Planning and Zoning Board Agenda October 13, 2020

SUBJECT: Site Plan – Hal Brady Recreation Center Maintenance Building: A request by Travis Hastay, P.E., of CHW, Inc., applicant and agent, for the City of Alachua, property owner, for consideration of a Site Plan to construct a $\pm 2,000$ square foot accessory structure (maintenance building) with associated stormwater and utility improvements on a ± 0.50 acre development area . Tax Parcel Number 03061-004-001 (Quasi-Judicial Hearing).

Planning & Community Development Department Staff Report

**RE: Hal Brady Recreation Center Maintenance Building (Site Plan)-
Development Review Team (DRT) Comments**

321B POTABLE (OR RECLAIMED) TRACER WIRE CONFIGURATION NTS

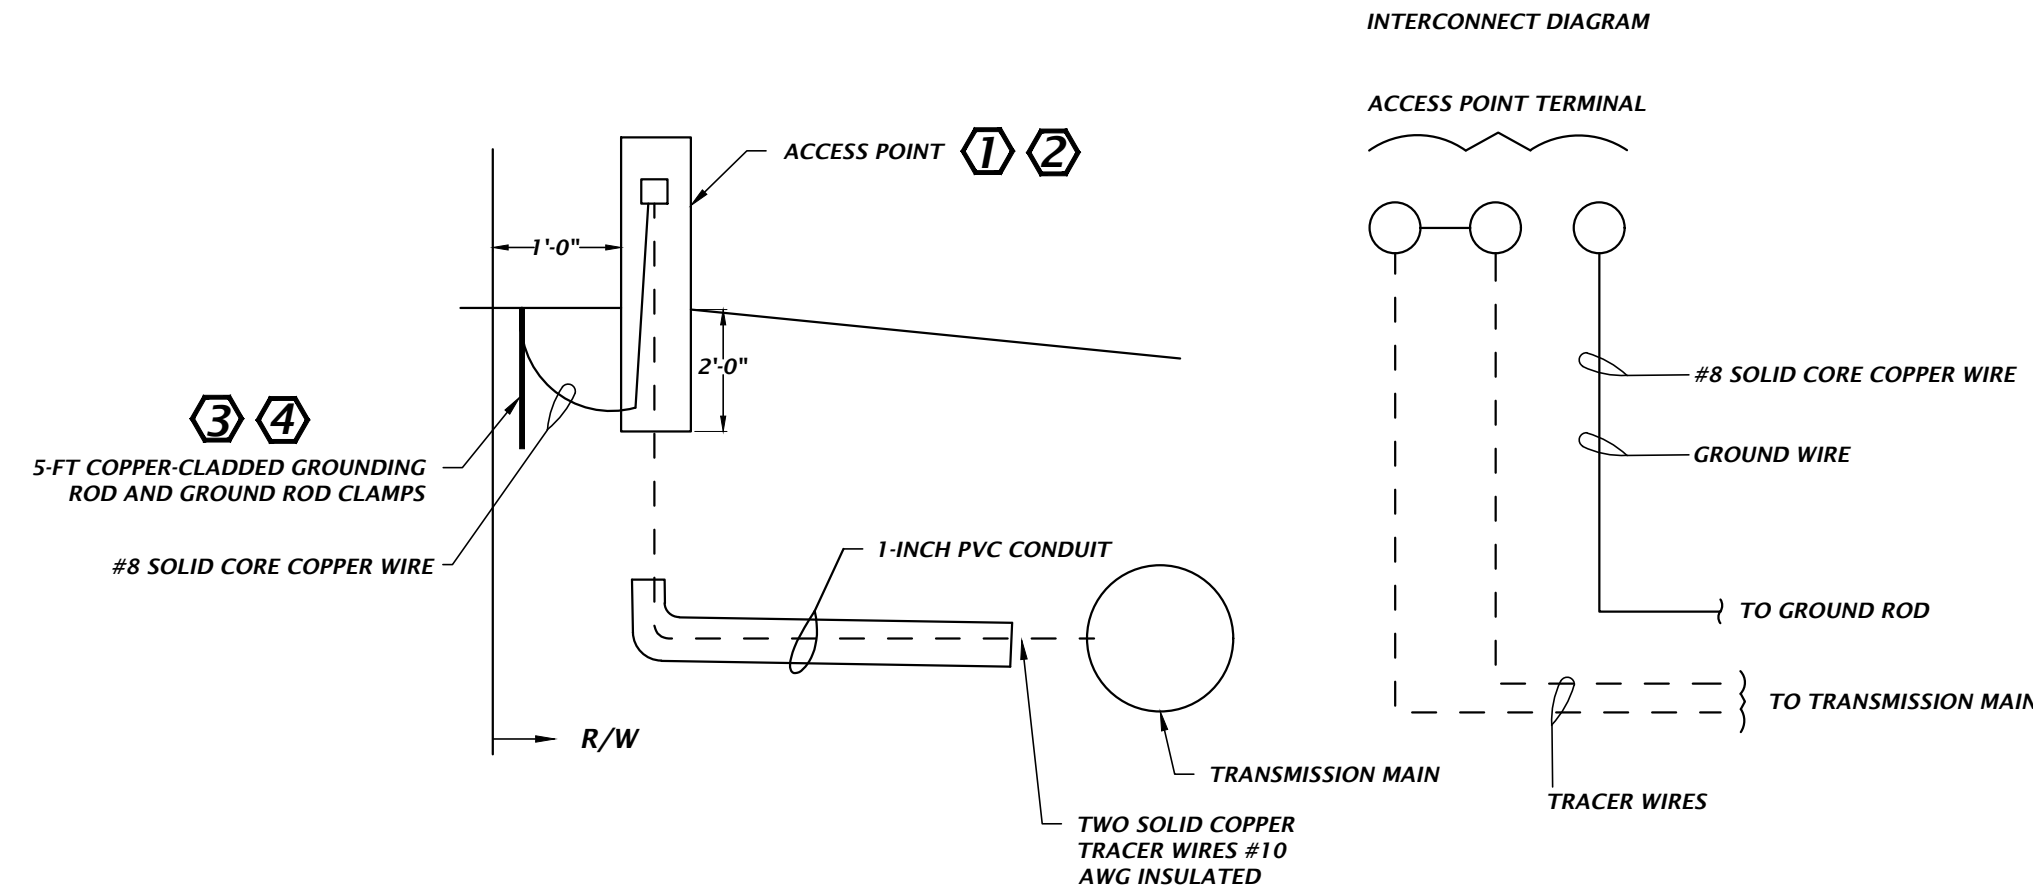
NO.	COMMENTS
	To Water and Wastewater General Notes, add the following: “17. The Contactor shall provide test assemblies and tracer wires to both metallic and non-metallic pipe as per City of Alachua design and details. 18. For the new water service, provide tracer wire and appurtenances starting from the taping saddle to the hose bibb. If the existing 3-inch service has a tracer wire, connect to it.”. Please include the following details: • 321A, 321B, 118 (SIMILAR), 145 (SIMILAR), 318(SIMILAR) Aug 10th Submittal Comment Approved

9.	June 30th Submittal Comment Supplemental Comment: Sheet C0.10 To Water and Wastewater General Notes, add the following: “17. The Contactor shall provide test assemblies and tracer wires to both metallic and non-metallic pipe as per City of Alachua design and details. 18. For the new water service, provide tracer wire and appurtenances starting from the taping saddle to the hose bibb. If the existing 3-inch service has a tracer wire, connect to it.”. Please include the following details: • 321A, 321B, 118 (SIMILAR), 145 (SIMILAR), 318(SIMILAR)

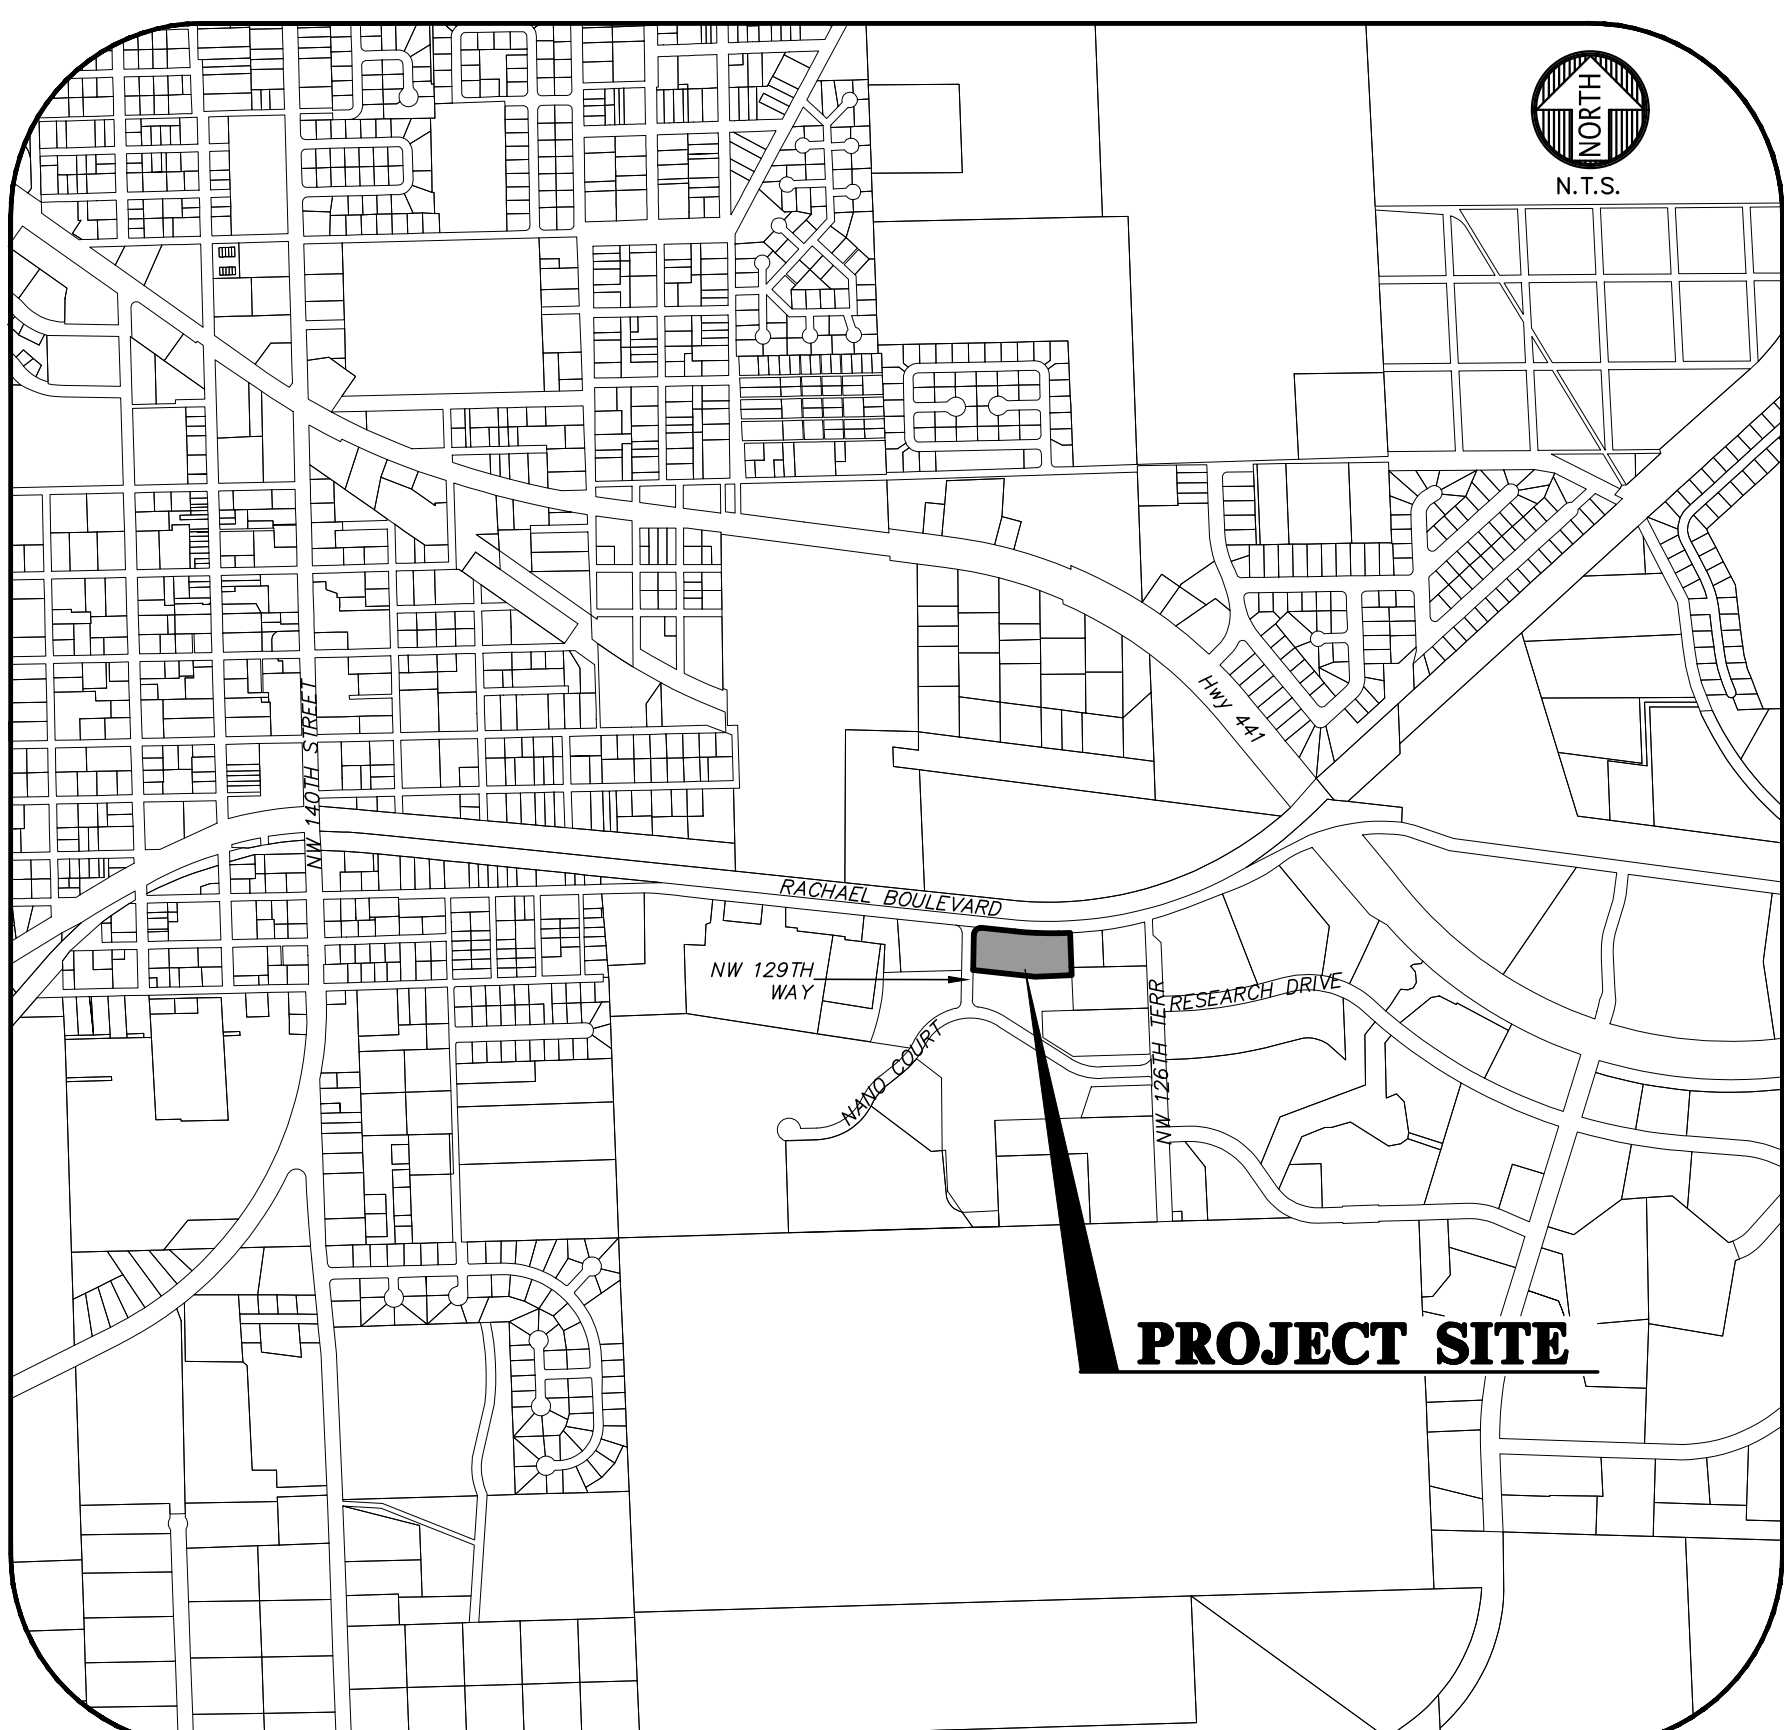
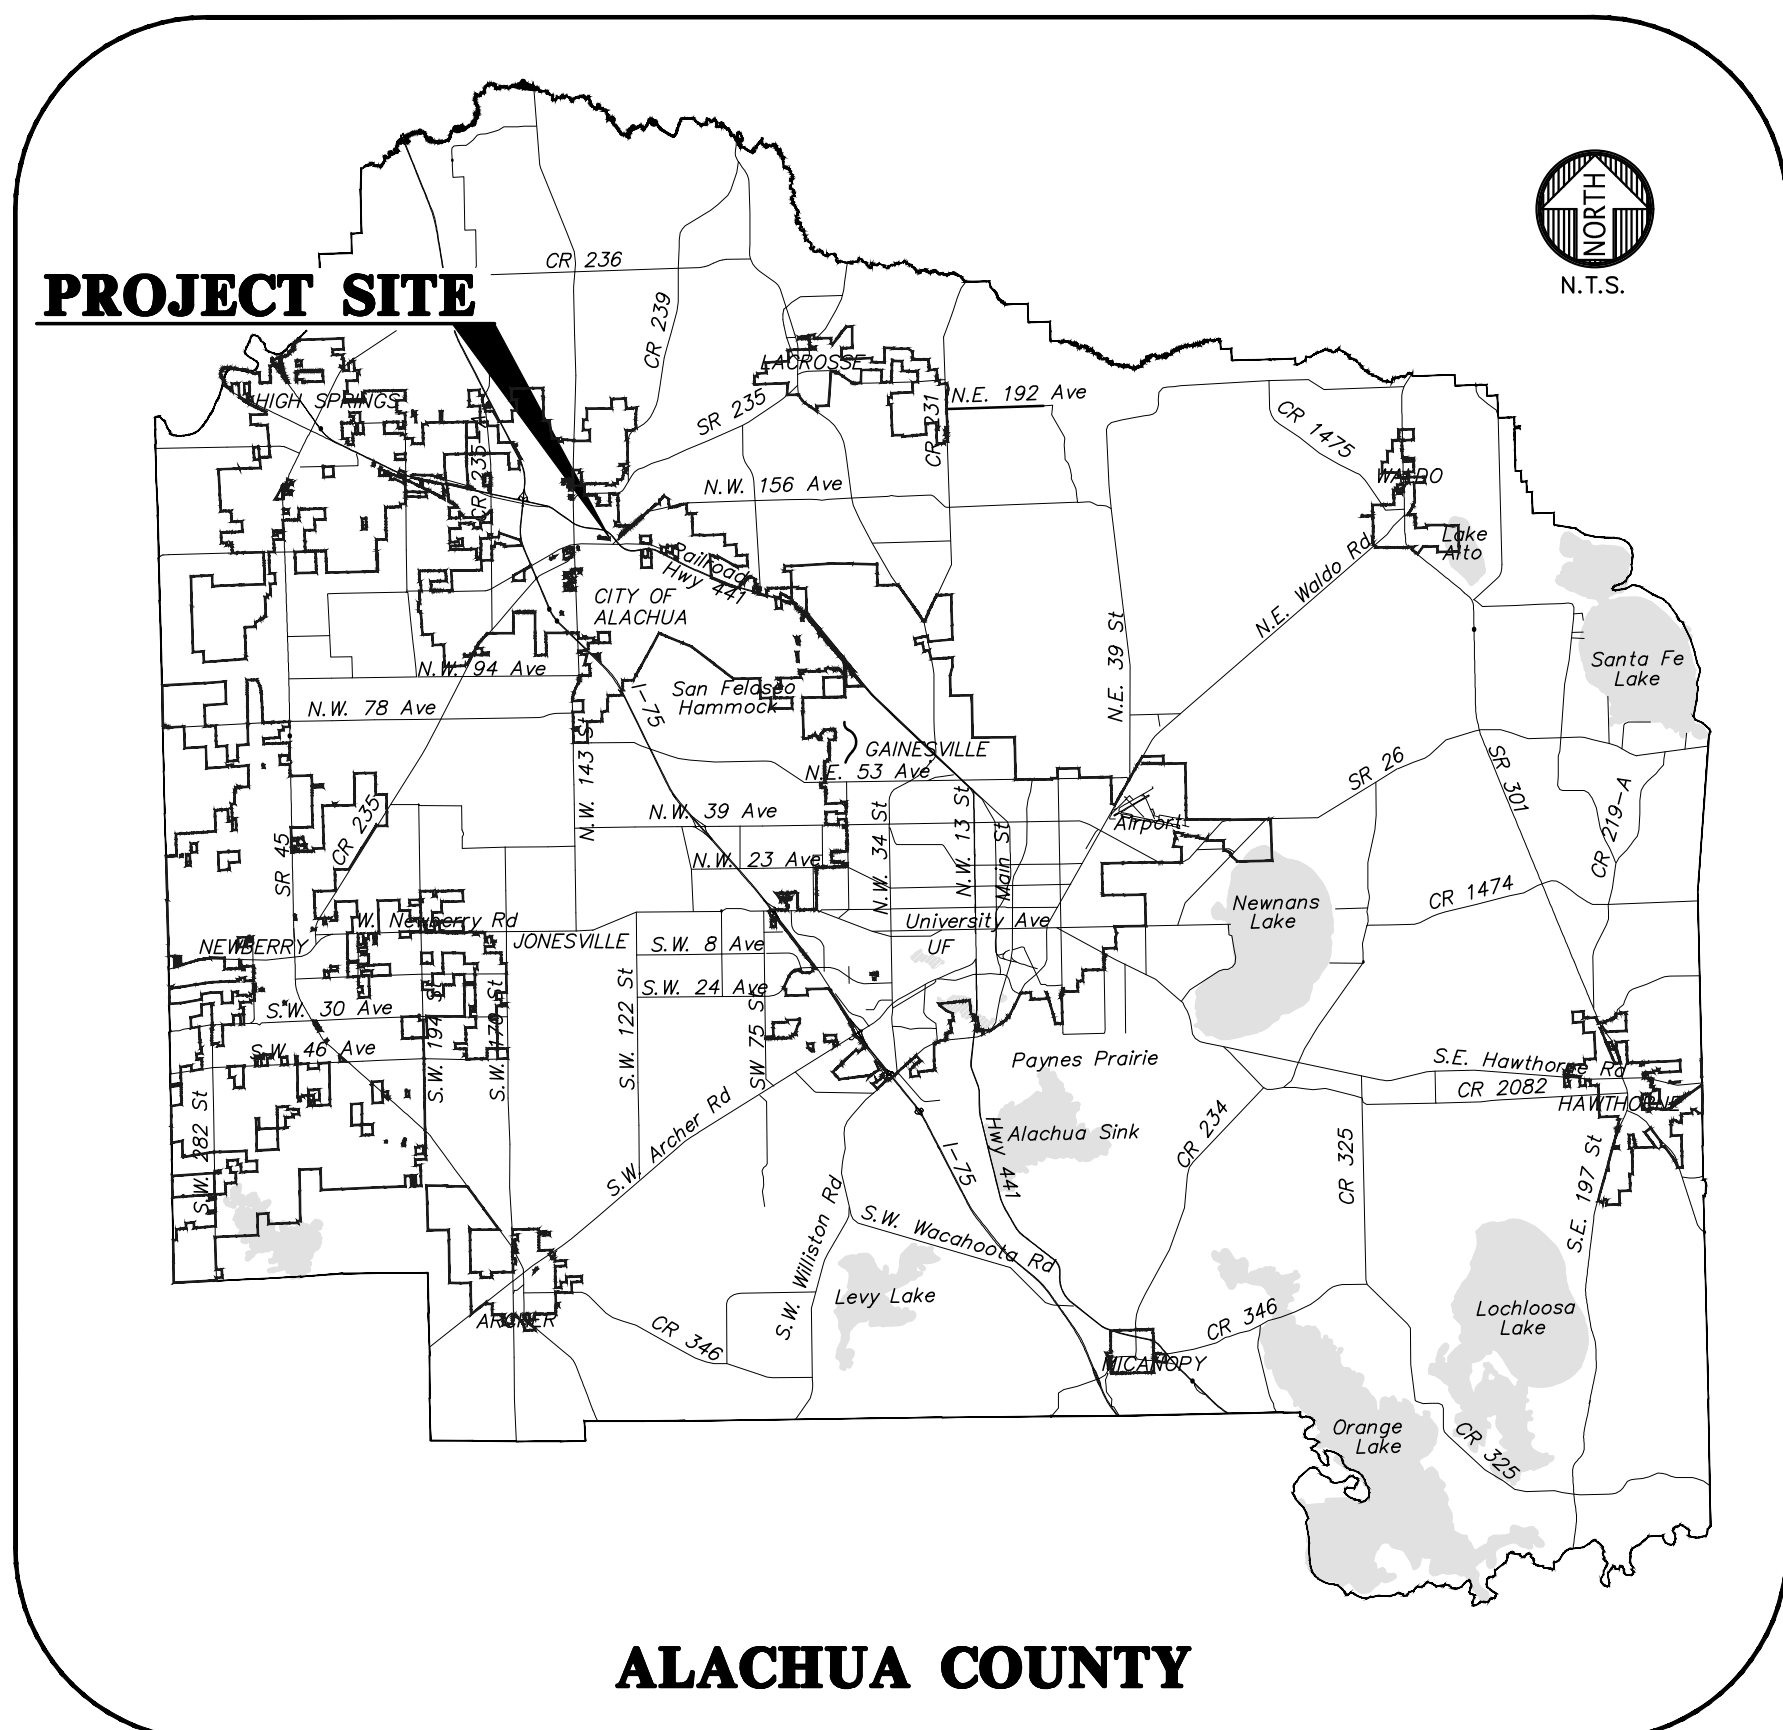
- a. The Vicinity Map on Sheet C0.00 does not reflect the project area as proposed by this plan.
- b. A portion of the land which was part of the 2018 plan has been acquired by an adjacent property owner to the east. This is not reflected on the plans.
- c. Sheet C2.31: Add detail number to the standard manhole detail.
- d. Sheet LS-1: The note under the Parking Area Landscape Requirements tables should reference Section 6.2 (not 6.9) and Section 6.2.2(D)(2)(**a**)(iii)(f).
- e. Sheet LS-2: The note under the Site Landscape Calculations table should reference Section 6.2 (not 6.9). Reference to Section 6.2.2(D)(1)(c)(v) is incorrect. This section pertains to business uses other than those in certain use categories, including manufacturing and production. Correct reference is to Section 6.2.2(D)(1)(**d**)(v).

- a. The Vicinity Map on Sheet C0.00 does not reflect the project area as proposed by this plan.
 - **The vicinity map has been revised. Please refer to sheet C0.00 for details.**
